# Wisconsin Department of Transportation

**Proposal #07: 4492-03-71, WISC 2020 384**  
**Racine Street Bridge, C of Menasha**  
**Fox River Bridge and Approaches**  
**Local Str**  
**Winnebago County**

This is Addendum No. 01, which provides for the following:

**ADDENDUM NO. 01**  
**PROJECT ID 4992-03-71**  
**July 30, 2020**

Addendum No. 01  
ID 4992-03-71  
Revised Sheet 594  
July 30, 2020

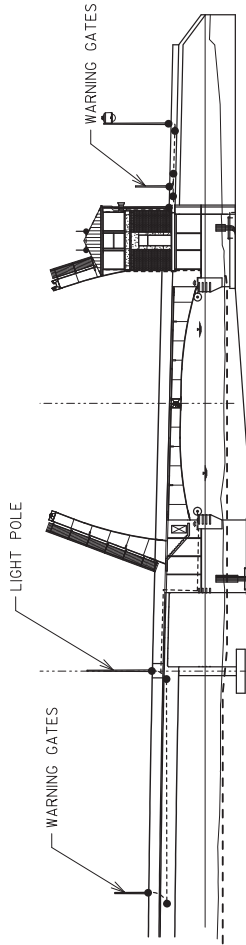
| Revised Plan Sheets |   |
|---------------------|---|
| 594                 | Grounding and Lightning Protection Details                                    |

| 1   | 07/22/20 | REVISED NOTE 5 | HVP |
